Project	IEEE 802.16 Broadband Wireless Access Working Group http://ieee802.org/16 >		
Title	MS CDMA BR Ranging in Transparent RS Systems		
Date	2007-05-08		
Submitted			
Source(s)	Kanchei (Ken) Loa, Yi-Hsueh Tsai, Voice: +886-2-2739-9616		
	Chih-Chiang Hsieh, Yung-Ting Lee, loa@iii.org.tw		
	Hua-Chiang Yin, Shiann-Tsong Sheu,		
	Frank C.D. Tsai, Youn-Tai Lee,		
	Heng-Iang Hsu		
	Institute for Information Industry		
	8F., No. 218, Sec. 2, Dunhua S. Rd.,		
	Taipei City, Taiwan.		
	[add other co-author here]		
Re:	IEEE 802.16j-07/013: "Call for Technical Comments Regarding IEEE Project 802.16j"		
Abstract	This contribution proposes procedures for MS CDMA BR Ranging in Transparent RS system		
Purpose	Text proposal for 802.16j Baseline Document		
Notice	This document has been prepared to assist IEEE 802.16. It is offered as a basis for discussion		
	and is not binding on the contributing individual(s) or organization(s). The material in this

MS CDMA BR Ranging in Transparent RS Systems

Figure 1 Examples of MR-BS and multiple RSs receiving MS ranging code in transparent RS system

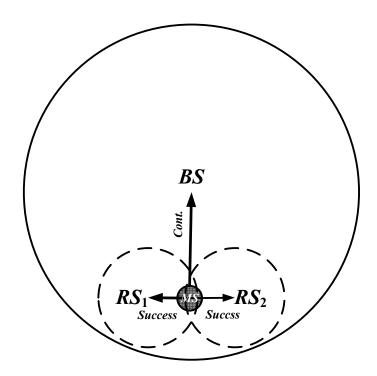
However, in an MR system with transparent RSs, the CDMA BR ranging code sent by MS might be received by the MR-BS and multiple RSs near the MS as shown in Figure 1. In order to decide the most appropriate path to communicate with the MS, every transparent RS must report the information of the received CDMA BR ranging code to the MR-BS in stage 1, as long as the CDMA BR ranging code can be decoded successfully. But, the schemes defined for stage 1 in the baseline document, which is applicable to non-transparent RS, cannot be used by the transparent RS since the MR_Code-REP message does not contain sufficient information for MR-BS making decision. In order to resolve the problem with minimum modifications on the baseline document, we propose a CDMA-based bandwidth request scheme for transparent RS that utilizes the RNG-REQ message instead of the MR_Code-REP message.
